**CanWhite Sands – Silica Sand Extraction Project
Environment Act Proposal –
File No. 6119.00
Public Comments Received From**

Comments on the CanWhite Sand Vivian Extraction Project
By
D.M. LeNeveu B.Sc (hons. physics), M.Sc. (biophysics). B.Ed.
On Behalf of What the Frack Manitoba
Oct. 5, 2021

Questions for CanWhite Virtual Open House for the Vivian Sand Extraction Project and Hydrogeological Report

Figure 2. Concentration of dissolved oxygen and Eh (ORP) values in groundwaters of Havana lowlands aquifer, 1985. (EPA, 1986)¹⁴

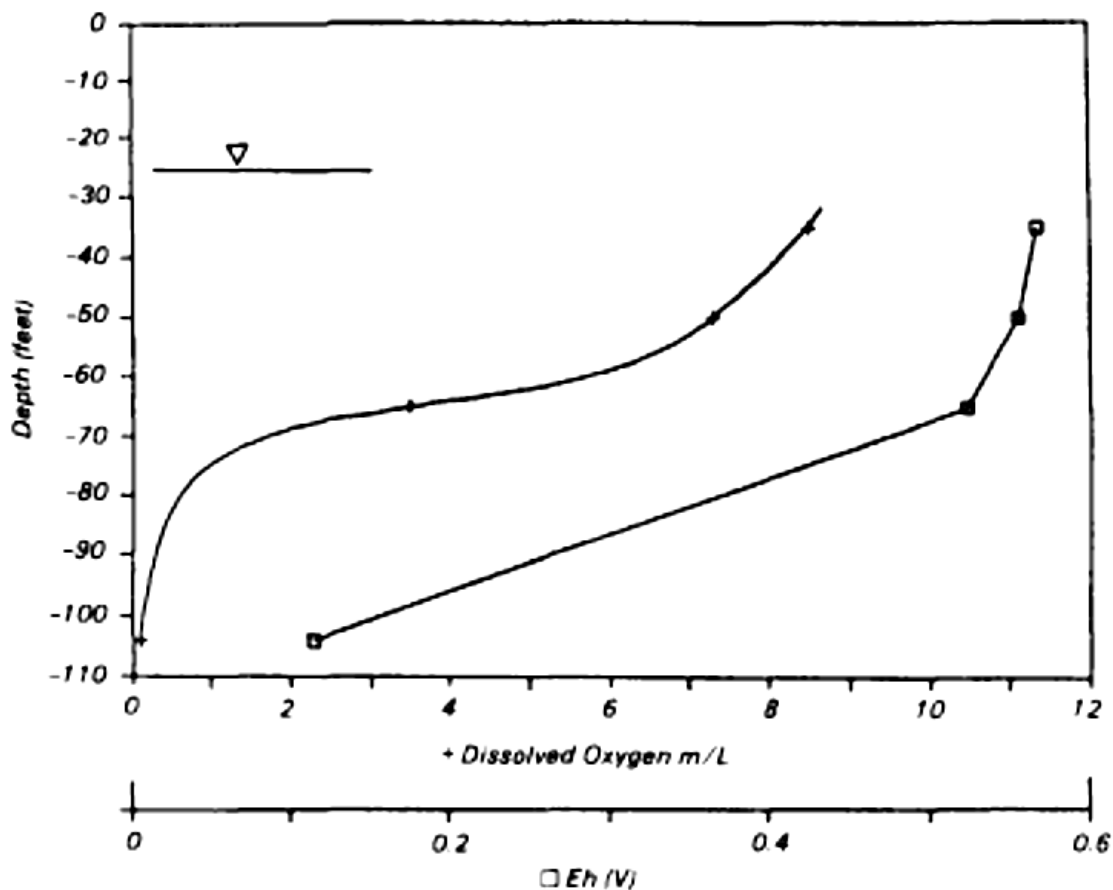
Dissolved oxygen generally decreases with decreasing oxidation reduction potential (ORP or Eh). For example US Environmental Protection Agency (EPA) report EPA/600/s2-86/042 of June 1986 for an aquifer in Cuba documented that dissolved oxygen concentration is zero below an ORP of 100 mV as shown in Figure 2.¹⁴

Figure 3. Limestone thickness in the CWS project area taken from drilling reports supplied by Manitoba Groundwater for CWS wells

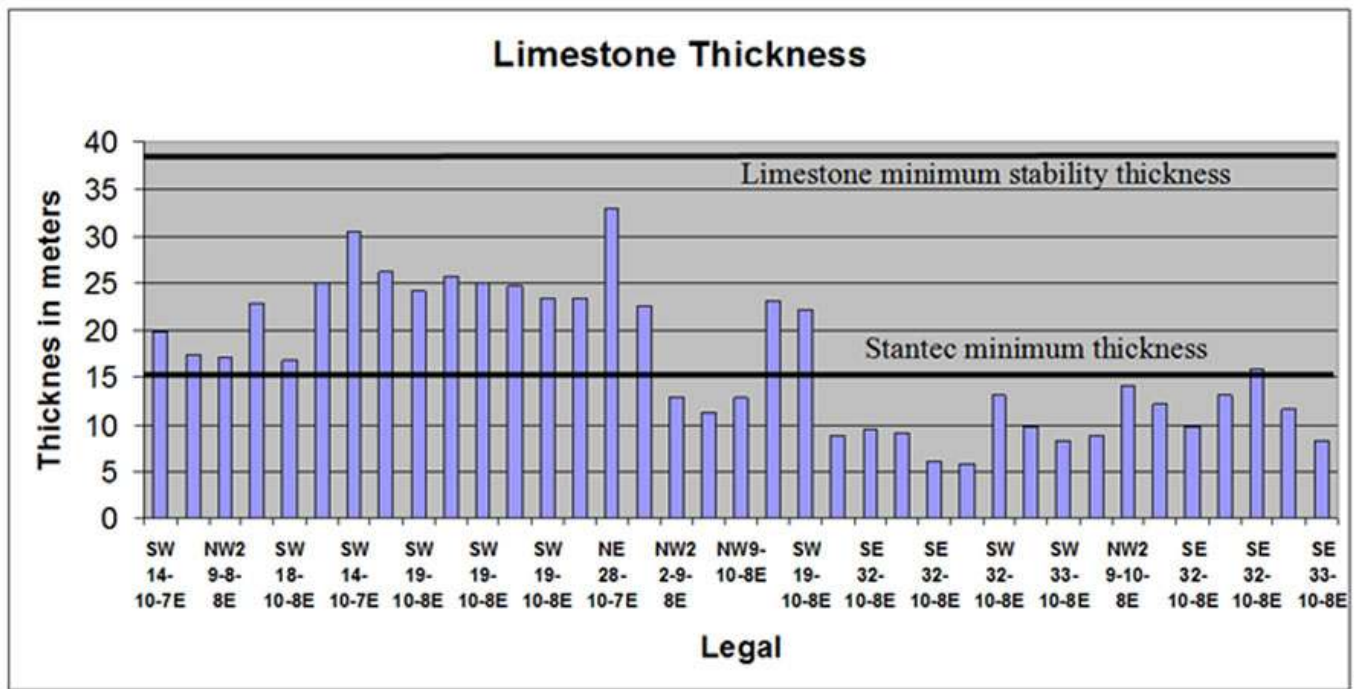
The core log for Bru 95-8 in the HGR report gives the limestone from 32.3 to 35.3 meter depth below surface to be weathered and incompetent. Thus there are 3 meters of incompetent limestone documented. This is followed by 1.6 meters of competent limestone to a depth of 36.9 meters. Next are 1.5 meters of limestone with small vugs which are small cavities. Limestone with vugs would not be competent. Next is a clay rich layer of 1.5 meters to a depth of 39.9 meters, followed by a 1.5 meters limestone with horizontal fractures to a depth of 41.4 meters. The clay layer and the limestone layer with horizontal fractures would not be competent. A final limestone layer 4.6 meters thick to 46 meters depth is reported with no comment as to integrity. In the column of limestone for Bru 95-8 there are at most only 6.2 meters of competent limestone out of the 13.7 meters. The Bru 95-8 core log is hard evidence supplied by CWS itself that the limestone in the Bru area is not competent or strong.

The full depth of the limestone for well Bru 95-8 at 13.7 meters is less than the Stantec limit of 15 meters. Figure 1 of the questions document illustrates that none of 37 drill reports give limestone thickness in the Bru area over 37.8 meters. In the eastern area where extraction would begin, most limestone thicknesses are less than the unverified Stantec limit of 15 meters. The figure of limestone thickness from the questions document is repeated here as figure 3.

Figure 4. Land Subsidence from CWS well clusters and subsequent aquifer damage and contamination from surface runoff and drainage.

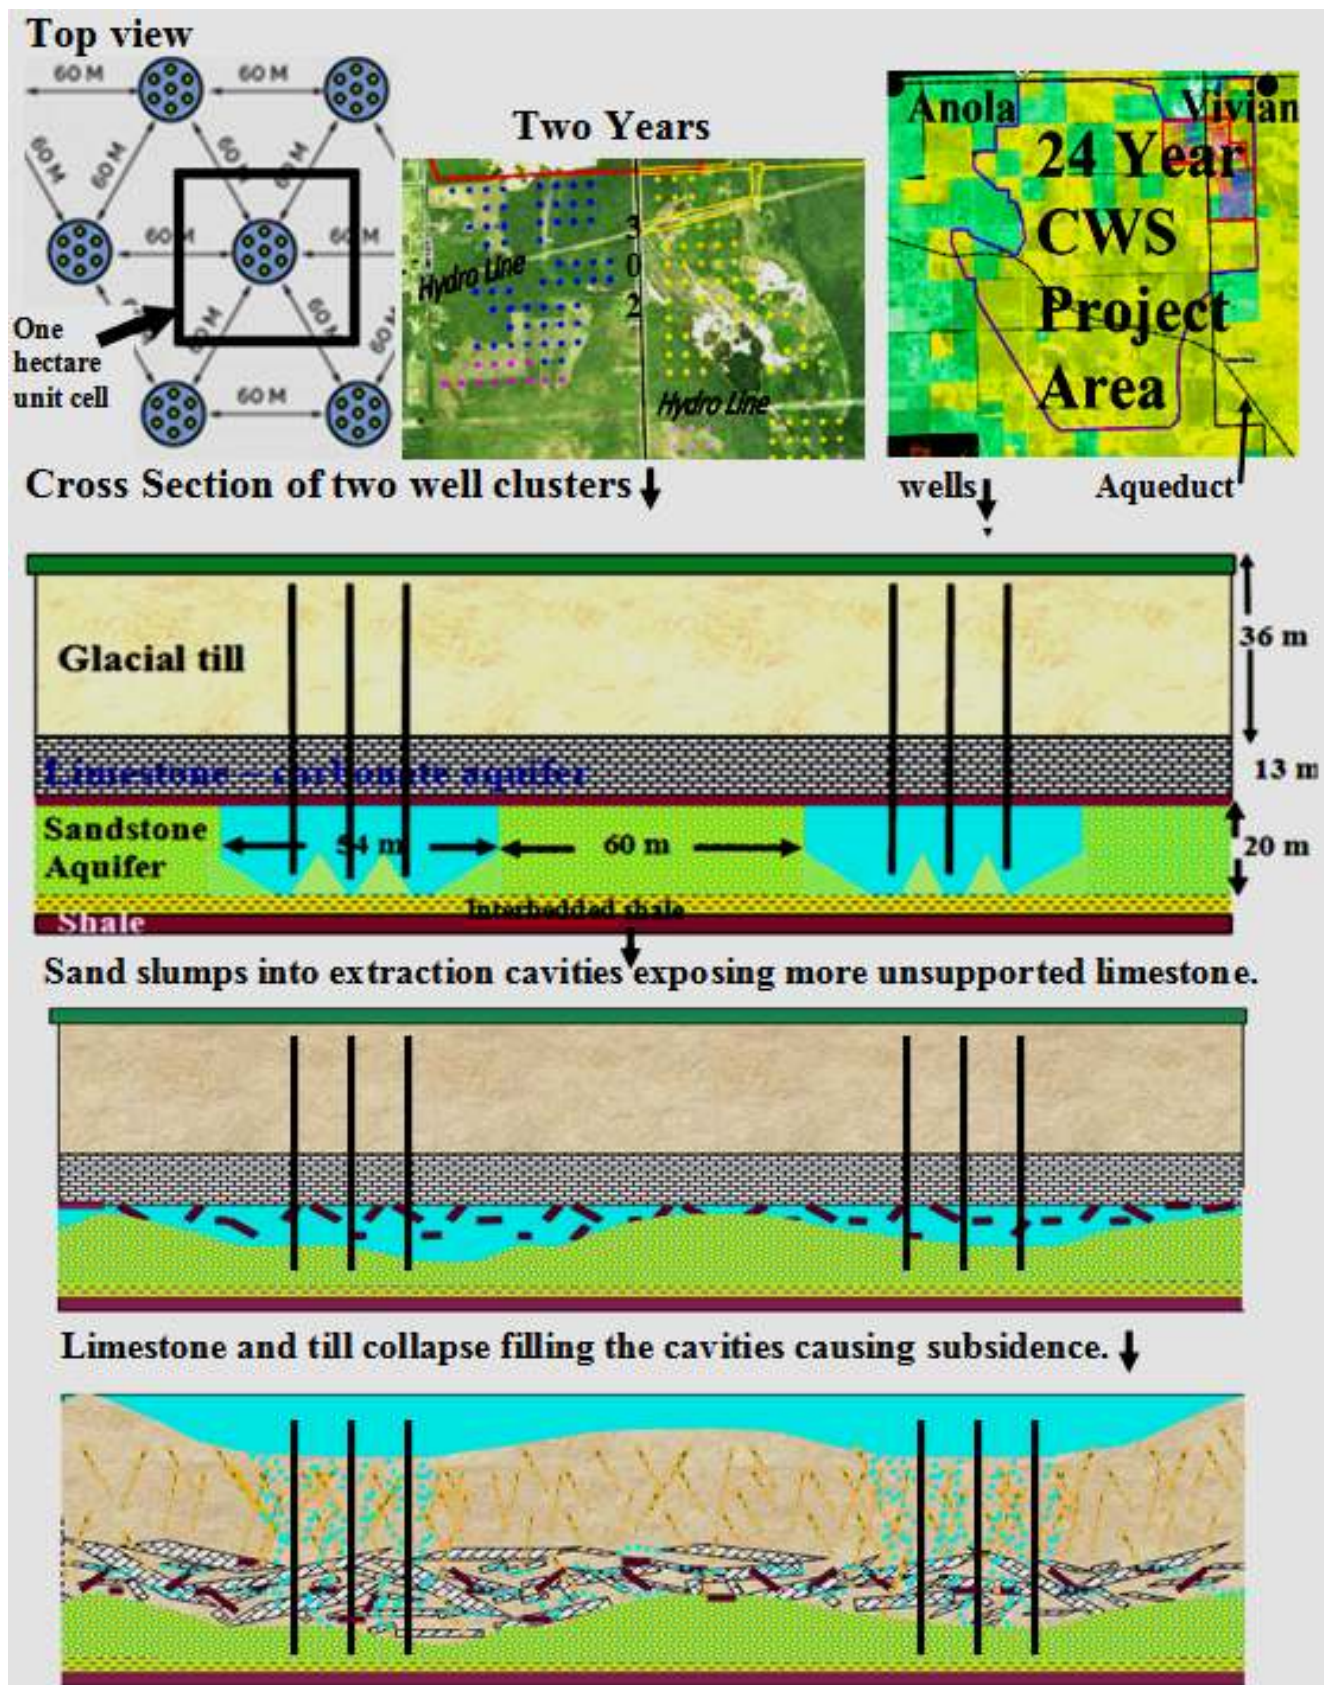
Sand slumping would enlarge the cavities under the well clusters creating an ever more unstable situation. Figure 4 illustrates the geometry of the well clusters and a unit cell within the clusters.

Figure 4 illustrates the progressive slumping of sand pillars into the excavation cavities and the subsequent collapse of the limestone layer. The subsidence and collapse would open the remaining carbonate aquifer to contamination from surface water runoff.

The unit cell in figure 4 is 114 meters wide by 98.7 meters high covering 1.12 hectares with a central cavity of 54 meters in diameter. The extraction EAP states that a cone of sand would be extracted around each well and that the wells in each well cluster are separated by 18 meters. According to the extraction EAP 3,000 tonnes of sand are to be extracted from each well in a well cluster. The actual volume of material extracted from each cluster would be greater due to the waste in terms of concretions and other over sized particles that are screened out at the extraction site.

Figure 4 illustrates the land disturbance that would affect the international 500kV transmission line and the Pointe du Bois power line due to land subsidence. The unconsolidated sand around the cavities would slump into the cavities gradually enlarging the area of the unsupported shale and limestone above. The limestone is not thick enough to support the cavities that would increase in size as the sand slumps. The land subsidence could cause the formation of swamps or wetlands around and crossing the hydro corridors. The subsidence would cause land depression and instability within and adjacent to the corridors and transmission lines.

Figure 8. Planned location of CWS well clusters up to 2025 from the CWS HGR

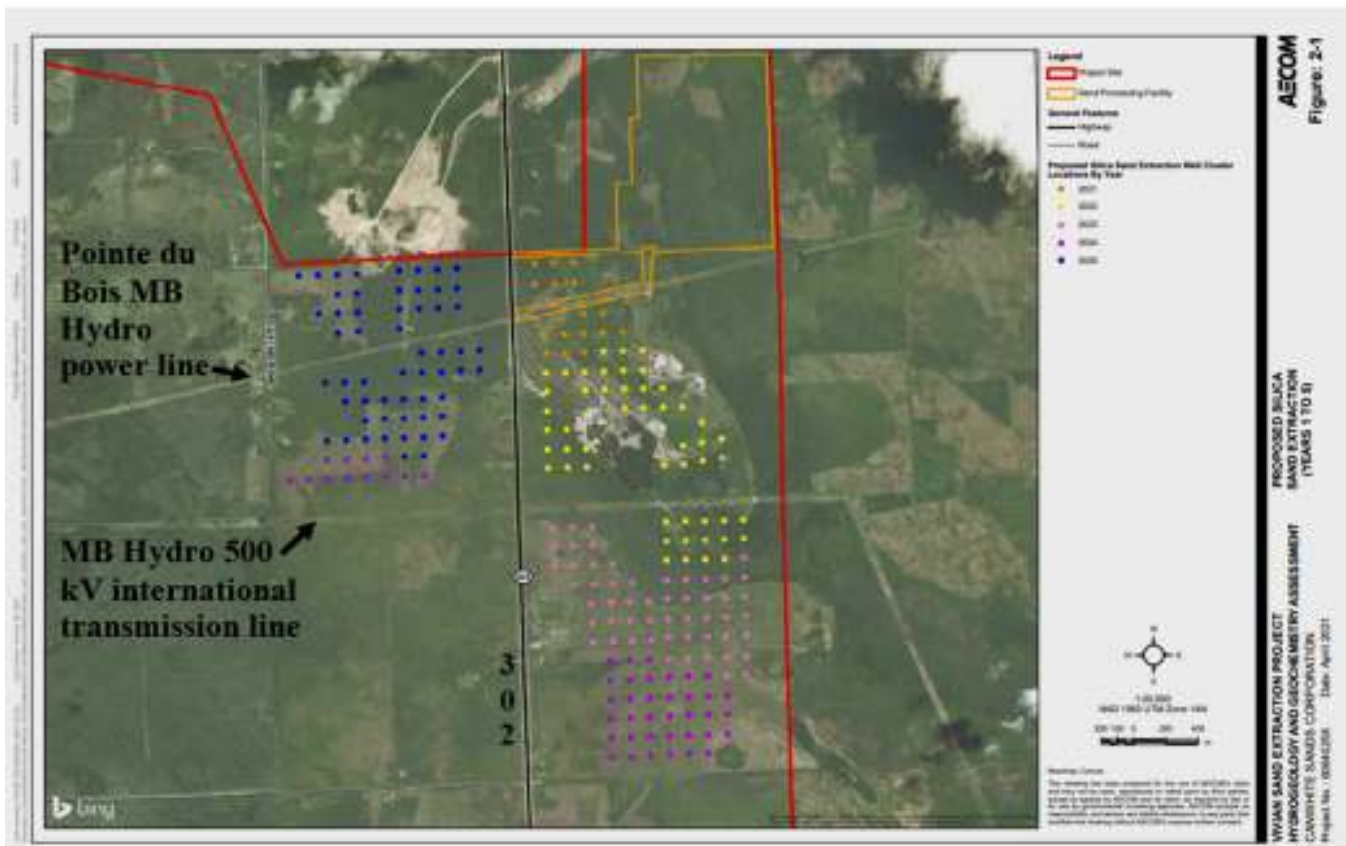
As shown in figure 8 the CWS well clusters up until 2025 would be on either side of the provincial highway 302. CWS slurry lines and heavy equipment such as vacuum trucks and drill rigs would be required to cross highway 302. To our knowledge CWS has not notified Manitoba Infrastructure nor obtained permission for the disturbance to highway 302. The land subsidence that could occur from the well clusters could destabilize the road bed and would affect road drainage. CWS should have identified these engineering issues and documented the risks and planned mitigation.

Figure 9. Location of MB Hydro Pointe du Bois power line, the MB Hydro 500 kV international transmission line, Winnipeg aqueduct and CN mainline.³⁷ The CWS project boundary is shown by the purple line

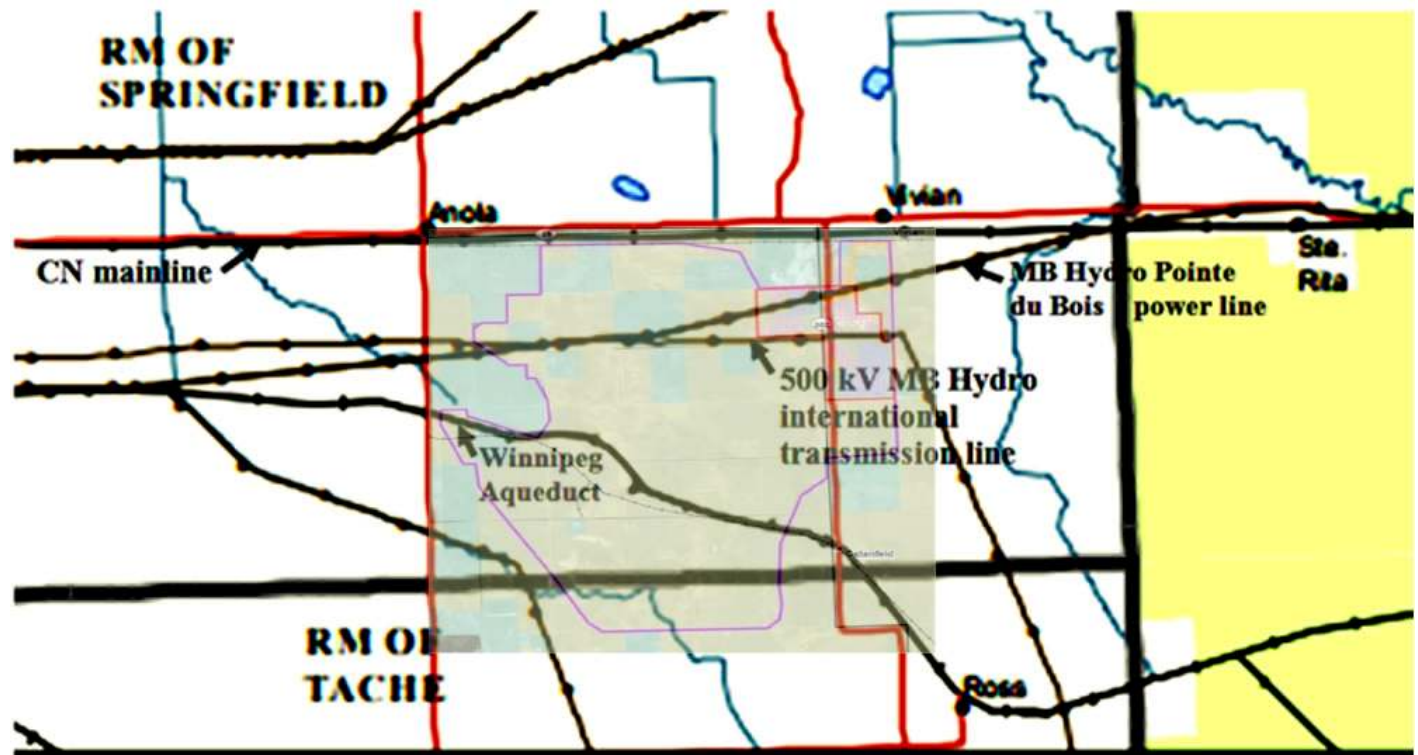
As shown in figure 4 and figure 9 the Winnipeg aqueduct traverses the entire CWS project area. The slurry lines and return recycled water loops would eventually have to cross the aqueduct likely multiple times. The aqueduct is known to have cracks that allow infiltration of surface water.²⁶ Slurry line spills near the aqueduct could contaminate Winnipeg's drinking water supply with harmful microbes, arsenic, selenium, other heavy metals and the highly toxic acrylamide monomer. A major break of the slurry line would leak at a rate of up to 24 cubic meters per minute as documented in the CWS processing plant EAP. The aqueduct could be submerged with a volume of about an Olympic sized swimming pool in two hours. A gradual undetected leak could infiltrate the aqueduct undetected for a long time. The land subsidence and wetlands created by the well clusters on either side of the aqueduct could destabilize the aqueduct and adversely affect drainage around the aqueduct. Flooding of the aqueduct from subsidence wet lands could occur.

The location of the MB Hydro Pointe du Bois power line and the 500 kV International Transmission Line to Minnesota as well as the Winnipeg aqueduct and the CN mainline railway are shown in figure 9.

Figure 1. Limestone thickness in the carbonate aquifer of the CWS BRU extraction area.

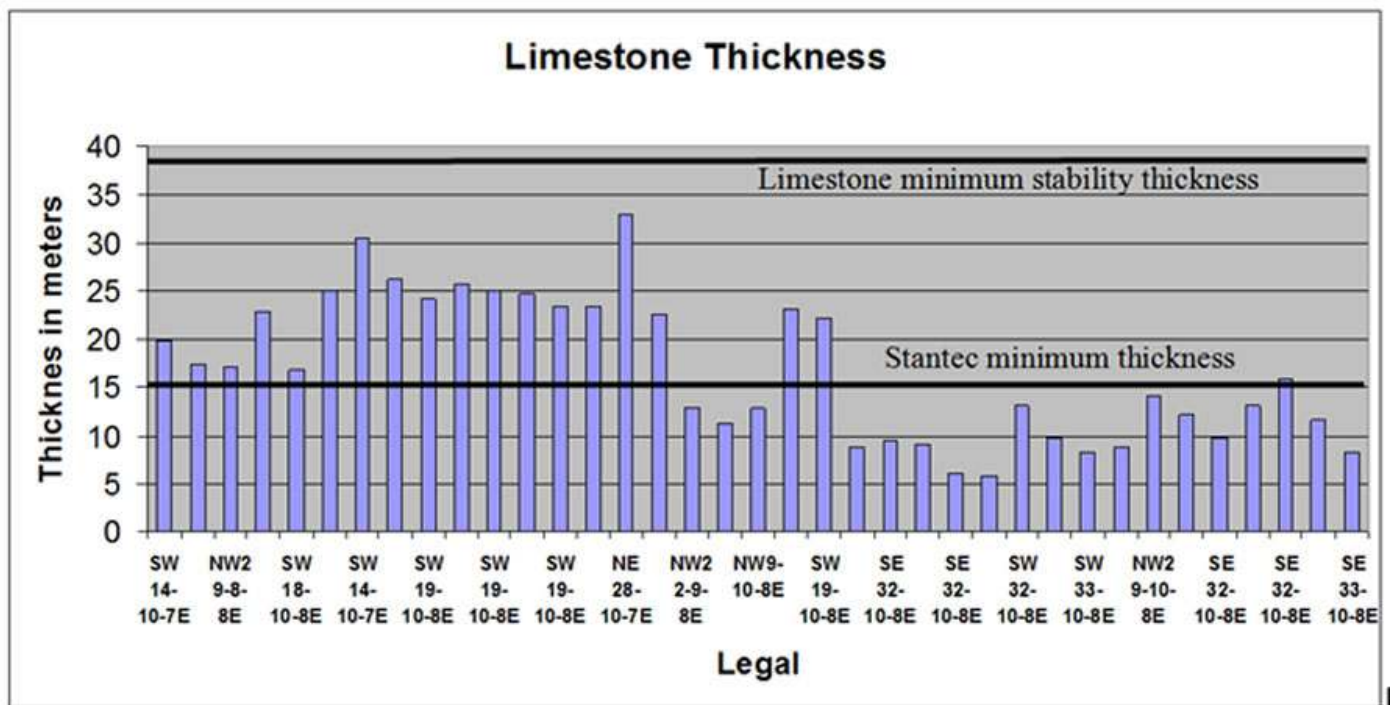
Figure 1 shows the limestone thickness of the carbonate aquifer in the Bru extraction area and the Stantec and Waltham and Fookes thickness limits. The data was taken from CWS well records supplied by Manitoba Groundwater and from the CWS borehole records in the hydrogeological report. The well records demonstrate that over the entire Bru extraction area all limestone thicknesses are less than the minimum criteria stated by Waltham and Fookes for stability. All limestone thicknesses in the eastern Bru area where extraction activities will begin are less than the Stantec limit of 15 meters. The limestone thickness in general increases westward.¹³

Will CWS move their operations westward into the ALY area where the limestone is thicker and the sandstone aquifer is saline to avoid subsidence?

Figure 4. CWS 24 year project area overlaid on the map of the extent of the Carman sands (green speckled area) south of Vivian MB.

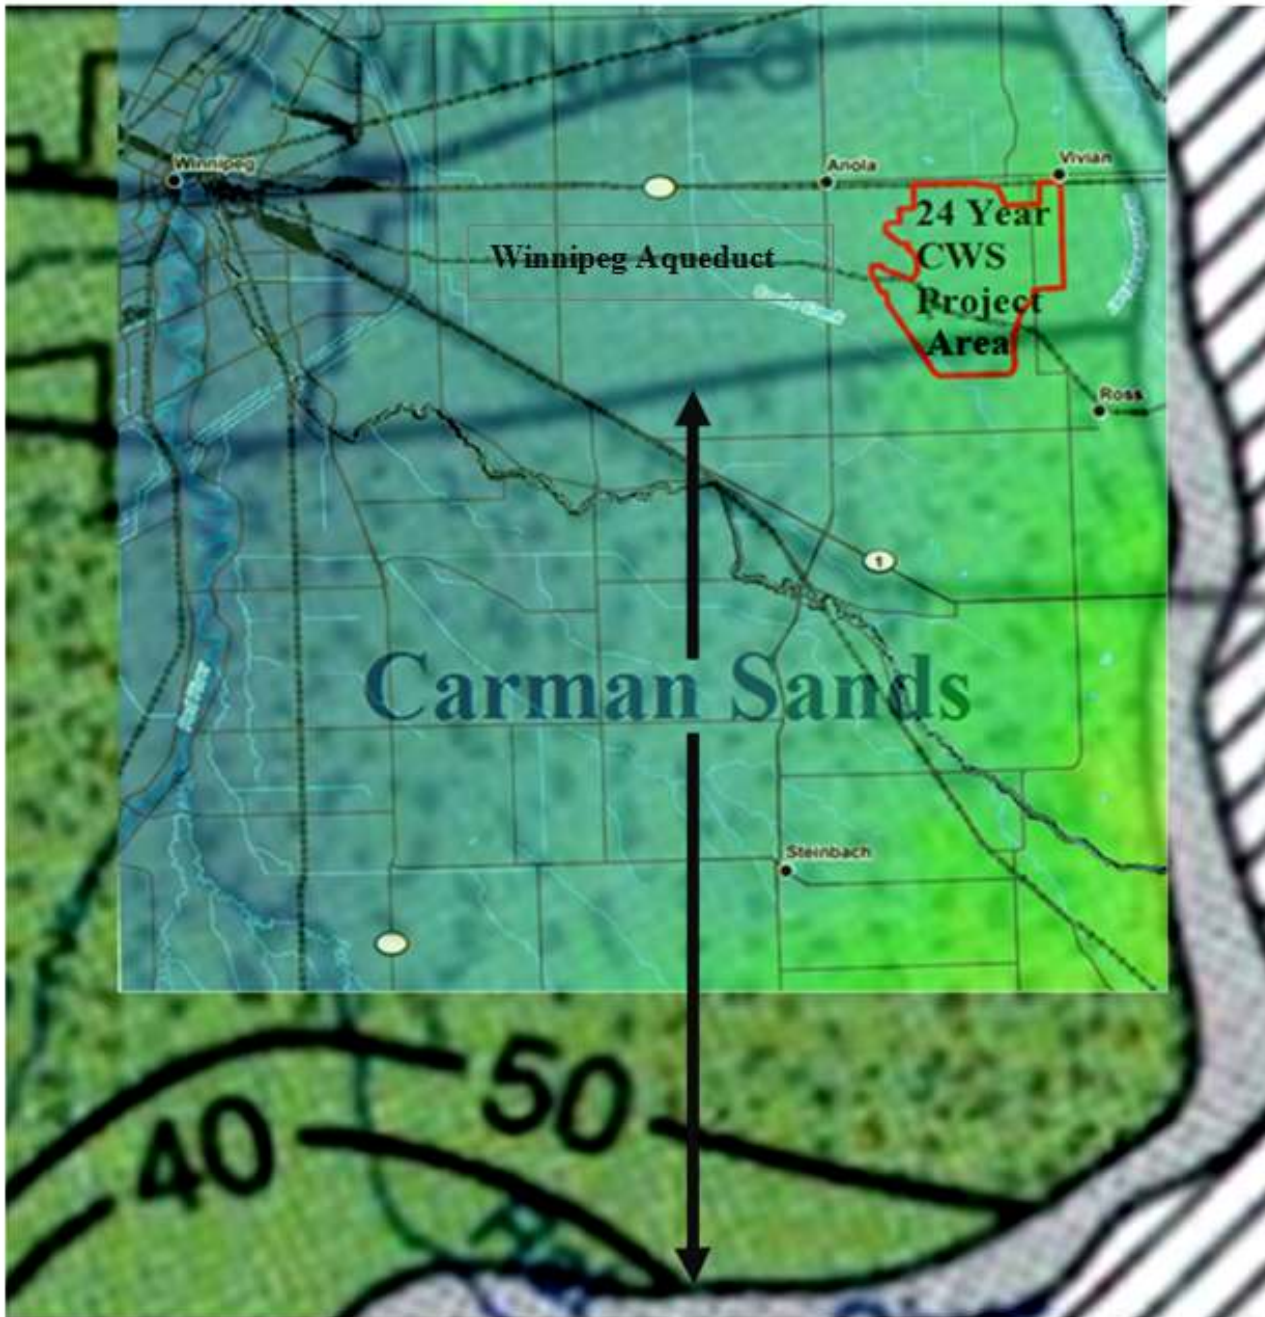
The above quote states the Carman Sands are below the Sandilands area. Figure 4 shows the Carman Sands as determined from the Manitoba Energy and Mines Bedrock Geology Compilation Map Series ¹³ overlaid on the CWS 24 year Project area. Figure 4 clearly shows only very southern portion of the project area is within the Carman sands.

Does CWS acknowledge the northern part of the BRU project area is wholly within the Black Island member part of the Winnipeg formation known to contain pyritic shale, marcasite coating the sand, pyritic concretions such as oolite layers and not within the Carman sands area?^{10,12,14,15} Does CWS acknowledge that the Black Island member from which sand will be extracted in the northern portion of the Bru area contains pyrite that will be exposed to re-injected aerated water that will form acid and mobilize heavy metals and selenium thereby contaminating the aquifer?
